Attachment 3 – Comment / Response Matrix

Public Comments

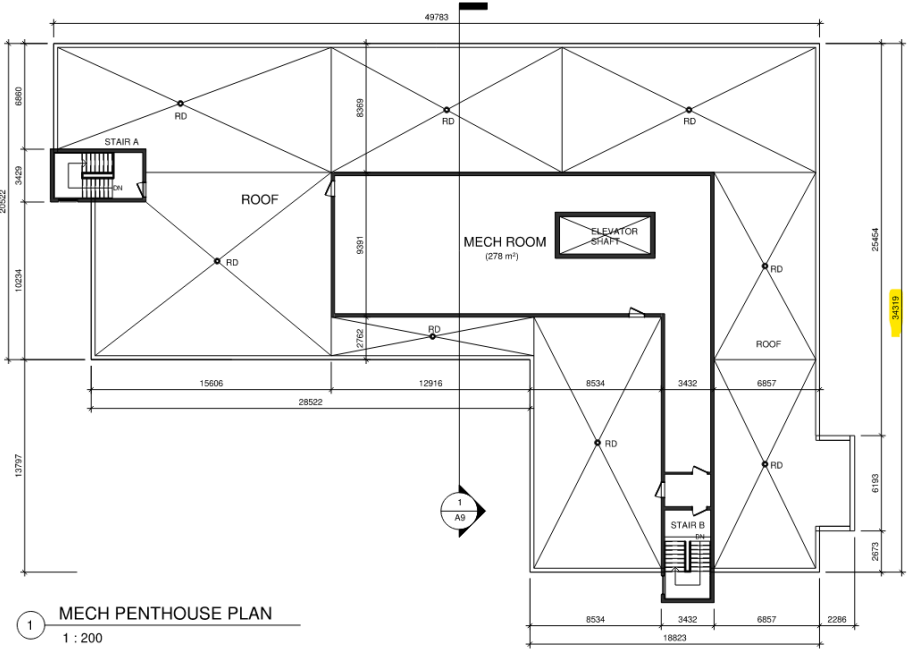
Hydro Transformer Box	There is a transformer box right next to the edge of the property which could produce noise and possible EMFs, this should be moved.	<p>Planning staff notes that hydro transformer boxes are typical features for developments of this nature and according to the site plan (Attachment 1) would be setback approximately 7.5 meters (24.6 feet) from the building on the adjacent property to the east.</p> <p>In response to concerns regarding noise impacts from the hydro transformer box to the rear of the proposed building, a fence along the easterly side of the proposed parking area that extends past the hydro transformer was added to the site plan as part of the third submission (see below). Within reason, details of the fencing can be further refined as part of the Site Plan Control process.</p> 
	The large transformer box is located too close to the building on the adjacent lot to the east. It should be moved to another location to lessen the effects of EMF exposure and the humming noise associated with them or some sort of shielding installed.

Construction Noise and dust	Imagine the years of construction noise and dust we (neighbouring residents) would have to endure while this building is being constructed.	<p>Planning staff do not possess the professional knowledge or expertise to comment on the design of the hydro transformer box and similar electrical safety matters. With that said, Planning staff are confident the design of the hydro transformer box will be reviewed by the appropriate authorities and in accordance with Health Canada guidelines and other applicable standards to ensure that exposures to Electromagnetic Fields (EMFs) are kept to a safe level.</p> <p>The implementation of dust control and other property maintenance measures during construction will be addressed in an eventual Site Plan Control Agreement that is required to be registered on title prior to commencement of construction. Noise and similar nuisances from construction are addressed in accordance with Town of Wasaga Beach Noise and Nuisance Bylaw 2019-15.</p>
